**CERTIFICATE OF APPROPRIATENESS**

**Property:** 1515 Columbia Street, Lot 9, Block 137, Houston Heights Subdivision. The property includes a Historic 1,302 square foot, one-story wood frame single-family residence situated on a 6,600 square foot (50' x 132') interior lot.

**Proposal:** Alteration – Remove inappropriate cladding and windows, along with other non-original elements, and construct a one-story addition beginning at the original rear wall connecting to a new proposed two-story alley loading garage at the rear of the property.

**HAHC Action:** Approved

**EAST ELEVATION – FRONT FACING COLUMBIA STREET**

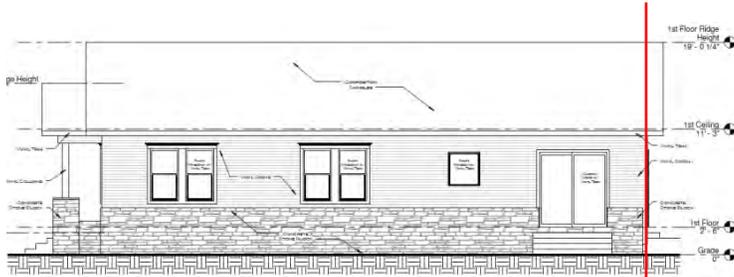
**Front Elevation:** The existing front elevation features two bays. The southern bay features the partial porch with a single window and door. The northern bay features a pair of windows. Both the porch and main portion of the house is topped by front facing gables.

The existing concrete simulated stone will be removed and the porch columns replaced. The existing wood under the vinyl will be restored. A portion of the proposed one-story addition will extend to the north. This addition will have a north facing gable. The two-story garage portion of the addition will extend to the south. The first-story of the garage portion will include a single door and no additional fenestration. The second-story will include a pair of windows. The garage will be topped by a side gable roof. See drawings for more detail.

**NORTH SIDE ELEVATION**

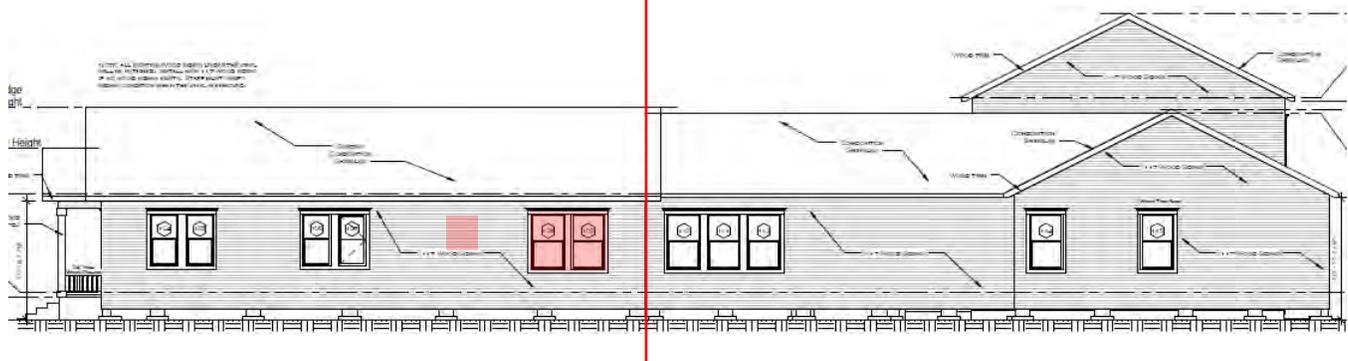
**Side Elevation:** The existing north elevation features the profile of the partial, inset porch to the east. To the west are two pairs of windows followed by a single fixed square window and a sliding glass door at the rear.

The existing concrete simulated stone will be removed and the porch columns replaced. The existing wood under the vinyl will be restored. On the existing structure, the fixed square window will be removed and sided over and the sliding glass door will be converted into a pair of windows. The one-story portion of the addition will be lower than the existing residence and will include a group of three windows. At the rear of the addition will be two additional windows. The two-story garage portion will feature no fenestration on this elevation. See drawings for more detail.

**SOUTH SIDE ELEVATION**

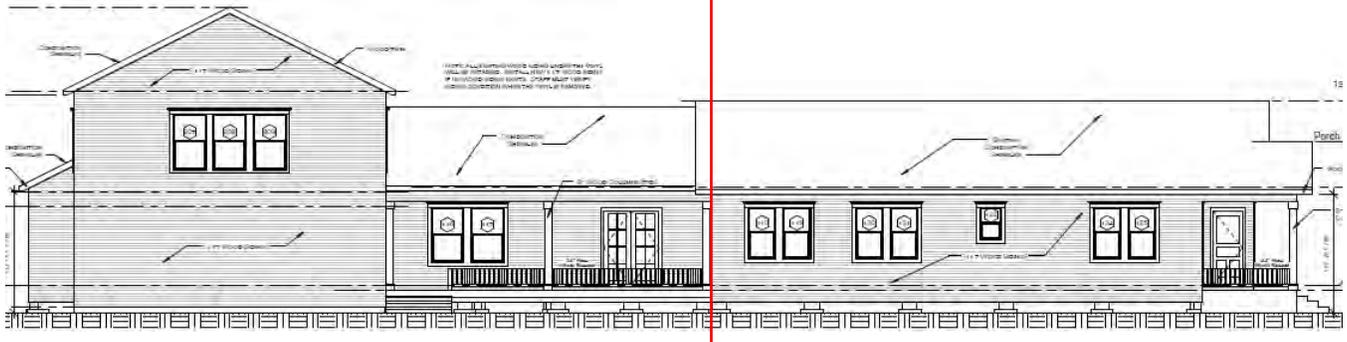
**Side Elevation:** The existing south elevation features the profile of the partial, inset porch to the east as well as a second side front door. To the west is a pair of windows followed by a single window and two additional pairs of windows.

The existing concrete simulated stone will be removed and the porch columns replaced. The existing wood under the vinyl will be restored. The one-story portion of the addition will be lower than the existing residence and will include a French door and a pair of windows located behind a side porch. The two-story garage portion will feature no fenestration on the first-story and a group of three windows on the second-story. See drawings for more detail.

**DEMOLITION PLAN**

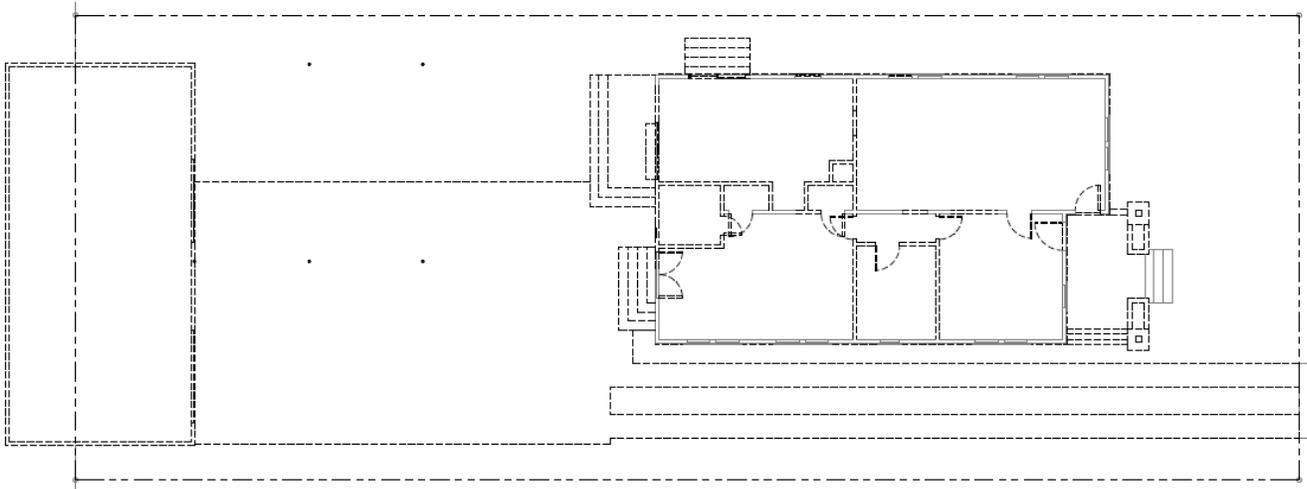
The existing rear metal addition and garage will be removed. The proposed addition will begin at the rear of the original structure. The proposed addition will be comprised of a one-story portion connecting to a rear one-story portion and a rear two-story garage. The one-story connector will be inset 1'-0" on both sides. The southern portion of the connector will include a 6'-7½" deep porch. The connector will extend 29'-6½" towards the rear on the south side and 33'-4" on the north. The rear one-story portion will extend out 4'-5" towards the north and will be 21'-4" wide by 28'-2" deep. The two-story garage will 22'-9½" wide by 27'-11½" deep and extend out 7'-10½" to the south. The one-story portions of the addition will have a ridge heights of 18'-6¼" and 18'-10½" (lower than the existing ridge). The two-story portion will have a ridge height of 27'-6". The bulky porch piers, planters, and columns will be removed and replaced with new 8" wood columns. See drawings for more detail.
